Request for Official Information responded to under the Local Government and Official Information and Meetings Act 1987 (LGOIMA) (the Act) – reference: OIR 2122-305

Further Information Request s92(1) and (2) – Resource Consent Application

Application number(s):	RM220070
Applicant:	Gresham Trust
Location:	240 Kapiti Road, Paraparaumu
Proposed activity(s):	A 311- lot subdivision and a 139 unit residential/medium density development and associated earthworks exceeding the permitted activity standards.

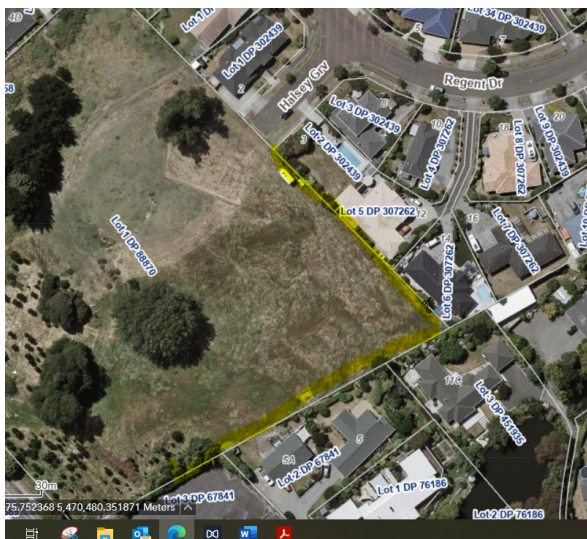
5. There will be around 1 - 3 meter deep cut along the neighbouring boundary highlighted as below. The Engeo Geotechnical report supplied doesn't address the effects on the neighbouring land due to the proposed activities and no recommendation is supplied to mitigate these effects. Geo-professional shall review the final earthwork plans supplied with RC application and provide and recommendation/ mitigation measures.

7. No recommendation is provided for proposed retaining wall. Geo-professional/ suitable qualified person to review the earthworks plan and provide construction methodology of proposed retaining wall (specially along the highlighted boundary below) to ensure there will be reduced impacts on the neighbouring land.
